Intersection ID: 17663	Main Street: TRANQUIL_AV	Cross Street: WESTFIELD_RD	Location:	W
ADA ID: 201AE61FC2CC	Ramp Type: BlendTrans2	Initial Pass/Fail: Fail	Overall Compliance: No	Severity Score: 21.25

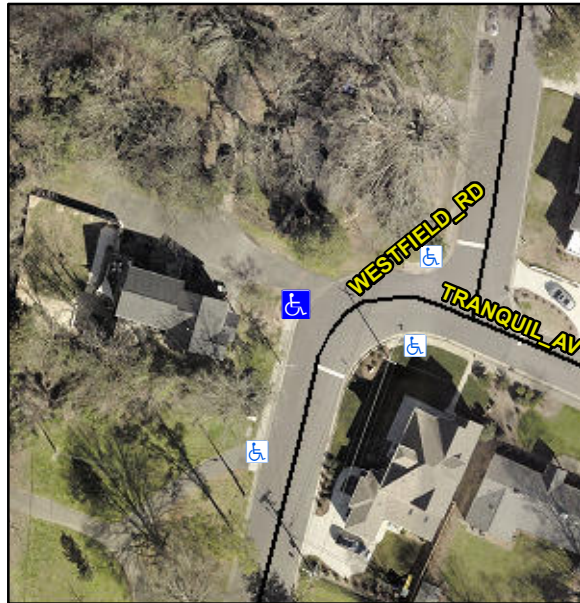
Not Found, R304.5.1, R304.5.3

Compliance	Description	Data	Compliance	Description	Data
N/A	Ramp Length (in)	48.0	Yes	BlendTrans Slope (%)	2.2
No	Ramp Width (in)	41.0	No	BlendTrans XSlope (%)	5.5
N/A	Flare Type LT	N/A	N/A	Flare Type RT	N/A
N/A	Flare Slope LT (%)	N/A	N/A	Flare Slope RT (%)	N/A
N/A	Flare Traversable LT?	N/A	N/A	Flare Traversable RT?	N/A
N/A	Landing Length (in)	N/A	N/A	DWS Provided?	N/A
N/A	Landing Width (in)	N/A	N/A	DWS Contrast?	N/A
N/A	Landing Slope (%)	N/A	N/A	DWS Length (in)	N/A
N/A	Landing X Slope (%)	N/A	N/A	DWS Full Width?	N/A
N/A	Landing Curb? (Y/N)	N/A	N/A	DWS Offset (in)	N/A
N/A	Shared Landing?	N/A			
N/A	Gutter Ponding?	N/A	N/A	Gutter Slope (%)	N/A
N/A	Gutter Lip Ht (in)	N/A	N/A	Gutter X Slope (%)	N/A
N/A	Painted X Walk1?	No	N/A	Painted X Walk2?	N/A
	X Walk 1 Direction	To SE		X Walk 2 Direction	N/A
	X Walk 1 Width (in)	N/A		X Walk 2 Width (in)	N/A
	X Walk 1 Slope (%)	5.0		X Walk 2 Slope (%)	N/A
	X Walk 1 X Slope (%)	1.6		X Walk 2 X Slope (%)	N/A

N/A	Ramp inside XWalk1?	N/A	N/A	Ramp inside XWalk2?	N/A
	Road Slope (%)	1.6		Clear Space?	N/A
	Road X Slope (%)	5.0	N/A	Clear Space to XWalk (in)	N/A
N/A	Any Obstructions?	N/A	N/A	Storm Grate/Utility Hazard?	N/A
	Obstruction Type			Storm Grate/Utility Type	
		N/A			N/A
			Yes	Surface Condition? (G/P)	Good
			No	Curb Slope (%)	6.9

Remove & Replace Curb Ramp With Two New Directional Ramps or Equivalent.
